UNITED STATES PATENT AND TRADEMARK OFFICE

APPLICATION NO.	FILING DATE	FIRST NAMED INVENTOR	ATTORNEY DOCKET NO.	CONFIRMATION NO.
10/555,723	11/07/2005	Andreas Smolarek	HEU-003USRCE2	2043

Office Action Summary	Application No. 10/555,723	Applicant(s) SMOLAREK, ANDREAS	
	Examiner GHASSEM ALIE	Art Unit 3724

Fig. 1

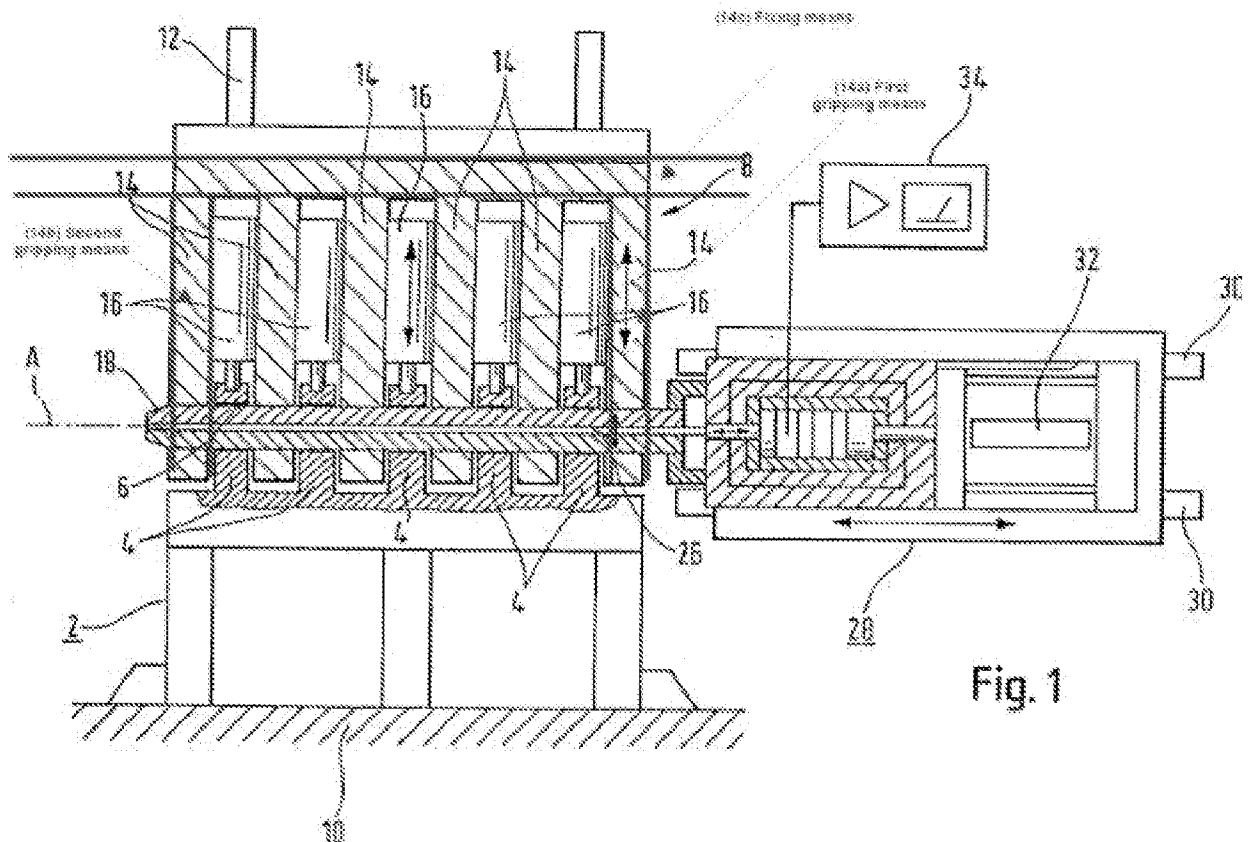
5. Claims 2-8 and 10, as best understood, are rejected under 35 U.S.C. 102(e) as being anticipated by Hahnel et al. US 2004/0011842, hereafter Hahnel. With respect to claim 2, Hahnel discloses a device configured to perform breaking separation of at least one bearing cap 4 from a corresponding thrust block in a bearing assembly an engine case provided with

With respect to claim 3, Hahnel discloses the device wherein said half-mandrel corresponding to said bearing cap comprises at least one recess (section 22 forms a recess) engageable with said gripping means 14a, 14b.

With respect to claim 4, Hahnel discloses the device wherein said half-mandrel corresponding to said bearing cap comprises, at its periphery on mutually facing sides, tangentially extending insertion slots (gaps formed between sections 24) for said gripping means, said slots being in communication with said at least one recess (the slots are "in communication" with the recess for actuator 26 because they are mounted on the same device)..

With respect to claim 5, Hahnel discloses the device wherein at least one recess (the final space after the furthest left raised section 24 on figure 2; between 20 and 24), when

viewed in an axial direction of said extension mandrel, is positioned axially adjacent to insertion slots (any of the sections 22 can be viewed as slots as they are in between raised portions 24) in each case and merges into said slots.

With respect to claim 6, Hahnel discloses the device wherein said gripping means 14a, 14b are formed by a first and a second pincer (any of the gripping points of the gripping means can be considered "pincers"), each of the first and second pincers comprise fixed jaws, , the jaws having, at their ends, engagement members facing towards one another.

With respect to claim 7, Hahnel discloses the device wherein said engagement members engage with at least one recess (flat portion 22 on mandrel 18; see figure 2) within said half mandrel corresponding to said bearing.
